UT to Town Creek Restoration Project – Option A Year 3 Monitoring Report

Subject: Task 9: Annual Final Monitoring Report – Monitoring Year 3 & Response to Comments
UT to Town Creek Restoration Project – Option A
Yadkin River Basin – CU# 03040105 – Stanly County, NC
NCDMS Project ID No. 94648; NCDEQ Contract No. 003277

Please find enclosed the Final Year 3 Monitoring Report and our responses to the Division of Mitigation Services (DMS) review comments received on December 14, 2018 regarding the UT to Town Creek Restoration Project – Option A, located in Stanly County, NC. In response to the referenced review comments, we have revised the Final Year 3 Monitoring Document, as needed. Each response has been grouped with its corresponding comment and is outlined below.

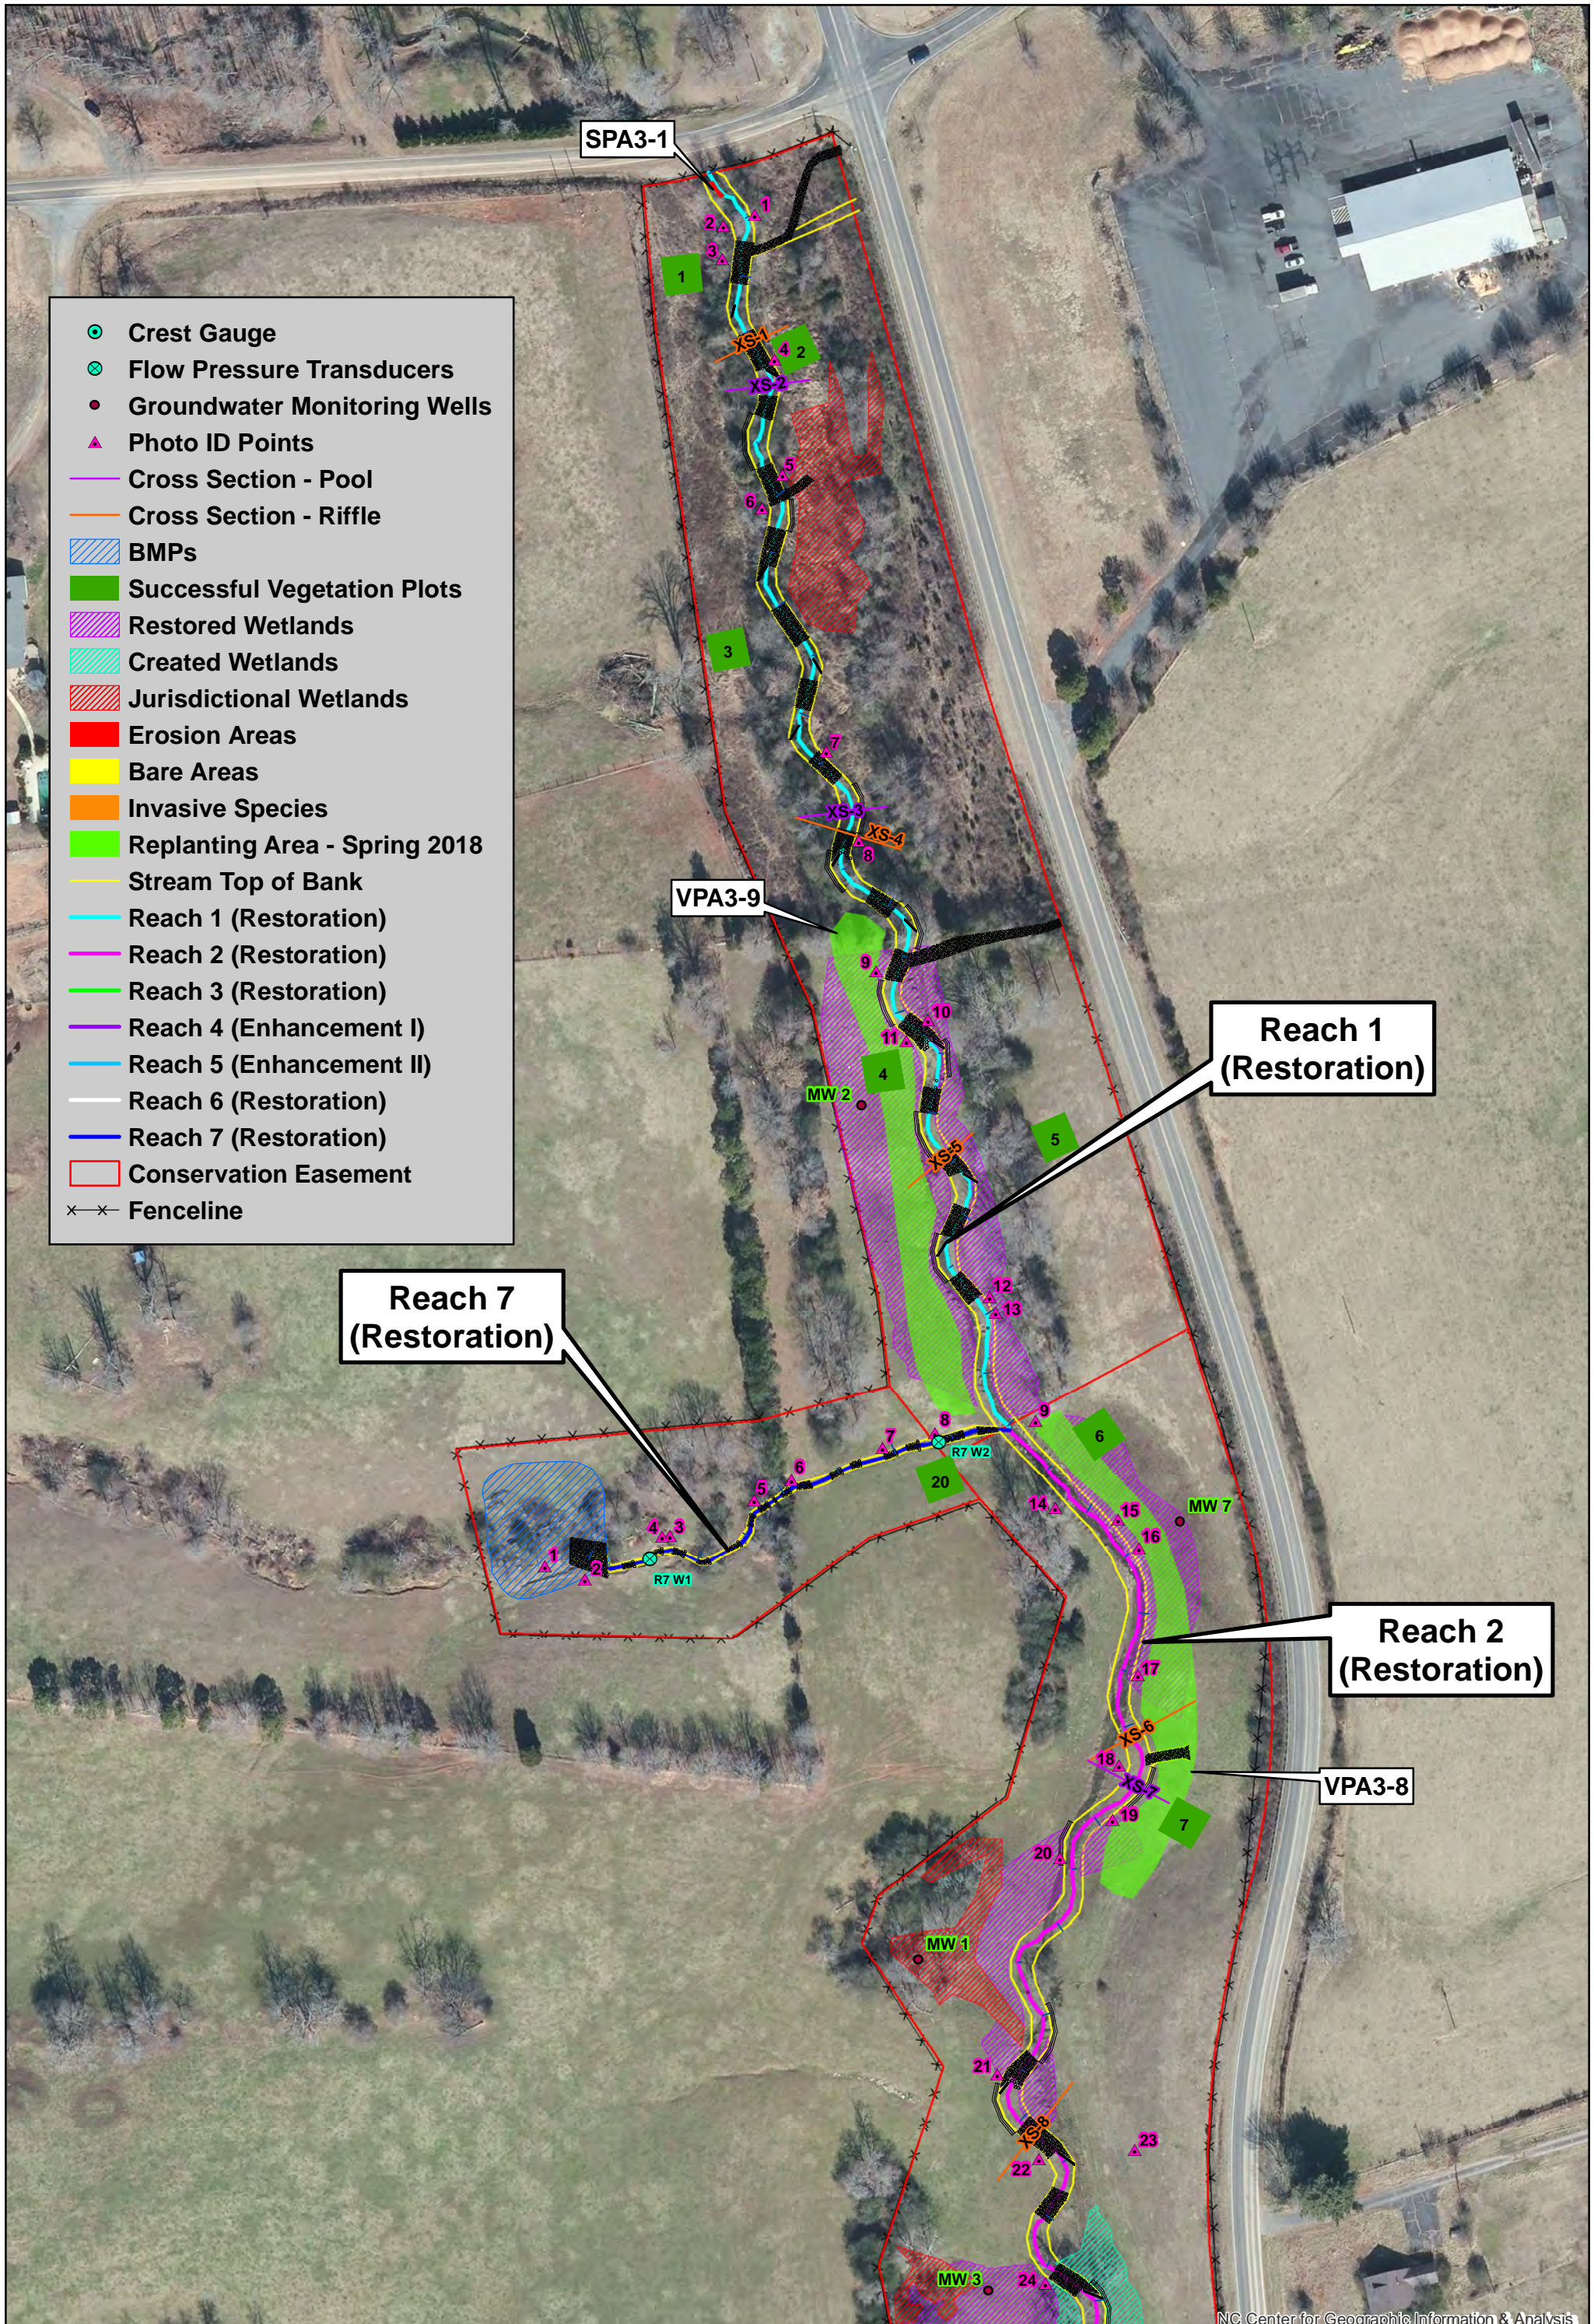
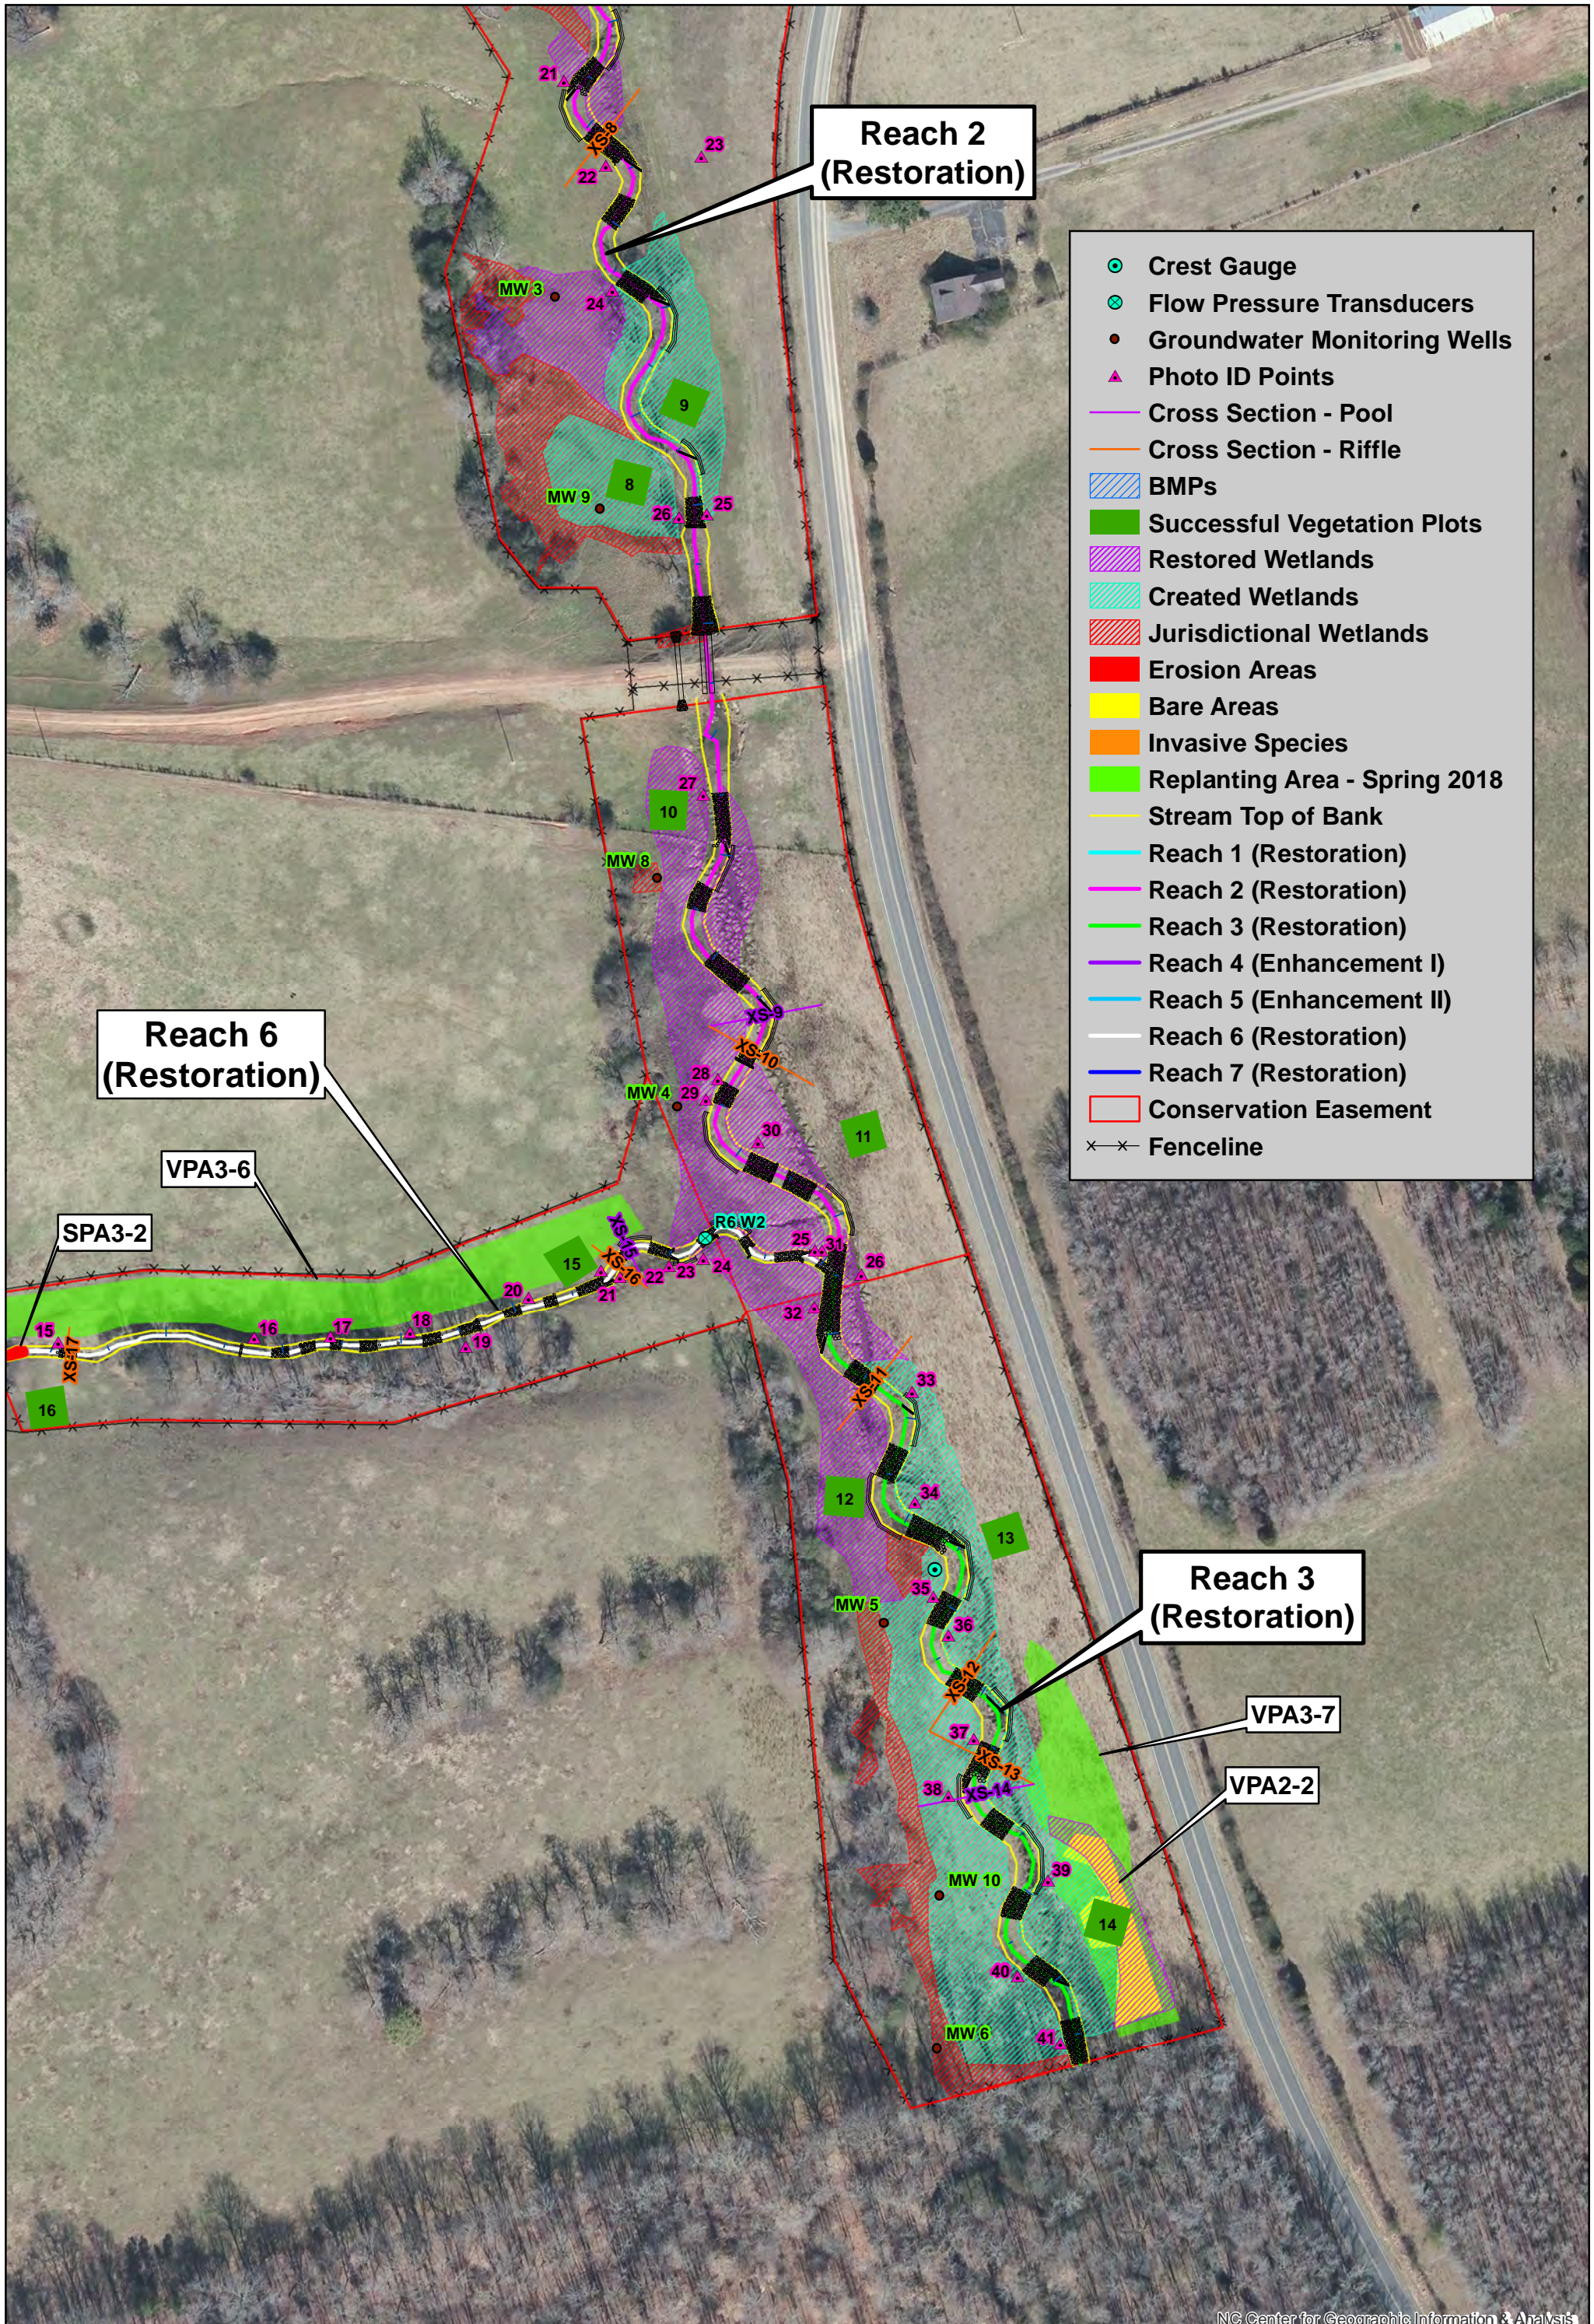
Table 6a – Invasive Areas of Concern indicates 0 polygons and 0.00 combined acreage. Even if individual “polygons” are below the 1000 SF threshold, the acreage of invasives as a concern should not be zero, based on my field assessment. Please provide an accurate estimate of acreage needing treatment for this table, as the existing numbers indicate the site is invasive-free which is not the case. Similarly, Bare Areas and Areas of Poor Growth or Vigor (e.g., Reach 3) should be cataloged accordingly.

Response – Table 6a and Table 6b have been revised to include vegetative problem areas (VPAs) throughout the project area. Figures 2 through 2c have been updated to reflect VPA locations. The MY3 report text has been updated to reflect VPA corrections.
